PROPOSED MULTI-FAMILY DEVELOPMENT

LOUISE BERRY DRIVE
BROOKLYN, CONNECTICUT

In response to review NECCOG comments on the referenced project dated July, 2020 we offer the following; please note that an additional sheet has been added to the plan set:

SANITARY SEWER
PIPE IN TRENCH DETAIL
NOT TO SCALE

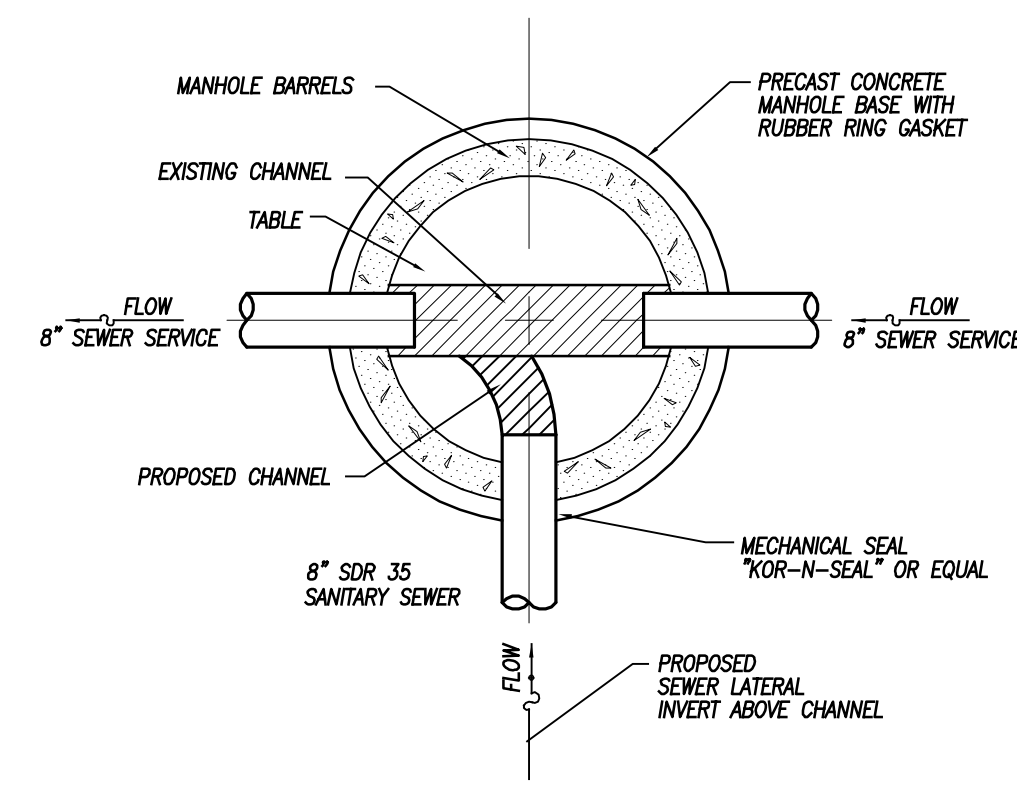
1. Curbing has been modified to a Cape Cod style curb.
2. The type of brick for the sanitary manhole has been specified on the plan.
3. The sanitary sewer pipe in trench detail has been modified accordingly.
4. Kor-N-Seal connections have been specified for the sanitary sewer connections.
5. Specification for the preservative retention and AWP classification of the guide rail has been added to the detail.
6. Guide rail is shown adjacent to the accessible units at the site entrance.
7. Speed limit sign has been modified accordingly.
8. The "No Outlet" sign detail has been modified accordingly.
9. The stop sign detail has been modified accordingly.
10. The retaining wall section has been modified accordingly. It should be noted that the detail was taken from the Versa-Lok website.
11. Roadway detail has been modified accordingly.
12. The sidewalk detail has been modified accordingly.
